# UNITED STATES PATENT AND TRADEMARK OFFICE

APPLICATION NO.	FILING DATE	FIRST NAMED INVENTOR	ATTORNEY DOCKET NO.	CONFIRMATION NO.
10/615,311	07/07/2003	Timo Kleinwachter	HOE-764	9366
20028	7590	05/19/2009	EXAMINER	
Lipsitz & McAllister, LLC 755 MAIN STREET MONROE, CT 06468			LANG, AMY T	
			ART UNIT	PAPER NUMBER
			3731	
			MAIL DATE	DELIVERY MODE
			05/19/2009	PAPER

<b>Office Action Summary</b>	<b>Application No.</b> 10/615,311	<b>Applicant(s)</b> KLEINWAECHTER, TIMO	
	<b>Examiner</b> AMY T. LANG	<b>Art Unit</b> 3731

## DETAILED ACTION

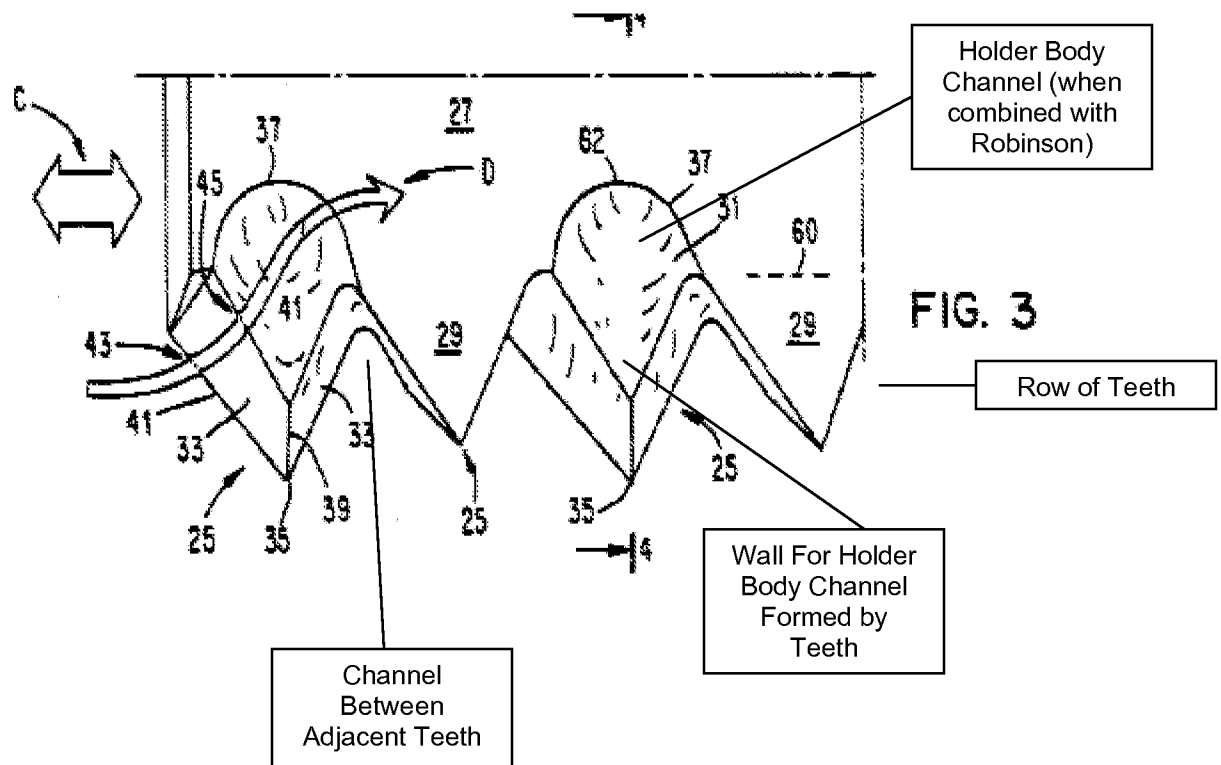
3. **Claims 1, 3-5, 7, 9-12, 13-20, and 22** are rejected under 35 U.S.C. 103(a) as being unpatentable over Miller et al. (US 5,306,285) in view of Robinson (US 1,894,832).

With regard to **claim 1**, Miller et al. (hereinafter Miller) discloses a surgical saw blade for cutting bone (column 1, lines 5-15) comprising a holder body (22, 53) and a row of teeth (25) (Figures 2A and 5A). As shown in Figure 5B, the holder body comprises two apertures, extending between lateral sides of the body. Therefore the apertures overlap the instantly claimed plurality of recesses. As shown in Figure 3, the teeth are formed at one end of the holder body and comprise three flanks. Additionally,

each tooth in the row of teeth is tetrahedral in shape. The first tooth flanks of every other tooth inherently lie in a plane (Figure 3). Channels are formed between adjacent teeth which are adapted to carry away the cuttings of material (Figure 3). As shown in Figure 3, the channels extend behind the tooth base and connect to troughs (31) (column 3, lines 14-20). Miller teaches the troughs collect the cutting material to increase durability and extend the life of the surgical saw blade (column 3, line 66 through column 4, line 17).

However, Miller does not disclose the troughs as connected to form a holder body extending along the row of teeth. Robinson discloses a comb comprising one trough (5) extending the along the row of teeth (4) (Figure 1). The trough is utilized to collect excesses material, similar to the troughs of Miller (column 1, lines 41-43; column 2, lines 73-75). A single trough advantageously collects excess material and allows for easy removal as well. Therefore, it would have been obvious to one of ordinary skill in the art at the time of the invention for the troughs of Miller to be joined and form one single trough that extends along the row of teeth. This single trough would then also form a recess.

The single trough of Miller in view of Robinson that forms the claimed holder body would extend along the row of teeth where the troughs (31) of Miller are located. Therefore, the teeth of Miller would form a wall for the single trough and the single trough would be interpreted by the channels formed between adjacent teeth.

With regard to **claim 3**, as shown in Figure 3 of Miller, the channels extend behind the tooth base at a depth of between 20% and 60% of the height of the tooth above the base. If Applicant were to argue that Miller does not specifically disclose the depth of each channel as 20% to 60% of the height of the tooth, it is the examiner position that at the time the invention was made, such channel depths would have been obvious to one having ordinary skill in the art. It has been held that where the general conditions of a claim are disclosed in the prior art, discovering the optimum or workable ranges involves only routine skill in the art. *In re Aller*, 105 USPQ 233 (CCPA 1955).

With regard to **claims 4 and 5**, as shown in Figure 3 of Miller, the channels are each formed in the form of a trough and are located between non-parallel tooth flanks of adjacent teeth.

With regard to **claim 7**, the holder body opening (54) is behind each tooth base (Figure 5A).

With regard to **claim 9**, the holder body opening is bounded by the row of teeth since the teeth provided an upper edge that serves to confine the holder body opening.

With regard to **claim 10**, as shown in Figure 5A of Miller, the holder body opening (54) is formed between a lower face and an upper face of the holder body (53) since this indentation penetrates through the two faces of the holder body.

With regard to **claim 11**, as shown in Figure 5B, Miller discloses two holder body channels that are parallel.

With regard to **claim 12**, although Miller does not specifically disclose the depth of the holder body channel with reference to the thickness of the holder body, at the time the invention was made, it would have been an obvious matter of design choice to a person of ordinary skill in the art to alter the depth of the holder body channel from 15% to 35% of the holder body thickness. It has been held that where the general conditions of a claim are disclosed in the prior art, discovering the optimum or workable ranges involves only routine skill in the art. *In re Aller*, 105 USPQ 233 (CCPA 1955).

With regard to **claim 13-15**, as shown in Figure 3, each first tooth flank, those which connect with a trough, is parallel with an upper face of the holder body. Therefore, the first tooth flanks of adjacent teeth are parallel. Additionally, the second and third tooth flanks are arranged at an angle to an upper and lower face of the holder body.

With regard to **claim 16**, the tooth tips (35) are displaced relative to one another with reference to a direction of width of the holder body (Figure 5A).

With regard to **claims 17 and 18**, the holder body extends substantially equidistantly between a first and second surface, the sides of the surgical saw as shown in Figure 4. The first tooth flank protrudes beyond the first or second surface.

With regard to **claim 19**, as shown in Figures 2A and 5A, the first tooth flank is substantially parallel to the first or second surface.

With regard to **claim 20**, although Miller does not specifically disclose the thickness of the holder body at the first tooth flanks is between 4% and 12% more than a spacing between the first surface and second surface, at the time the invention was made, it would have been an to a person of ordinary skill in the art to alter the thickness of the holder body and spacing between the tooth flanks. It has been held that where the general conditions of a claim are disclosed in the prior art, discovering the optimum or workable ranges involves only routine skill in the art. *In re Aller*, 105 USPQ 233 (CCPA 1955).

With regard to **claim 22**, hub (22) comprises a receiving portion that connects to a handpiece which powers and oscillates the surgical saw (Column 4, lines 34-36).
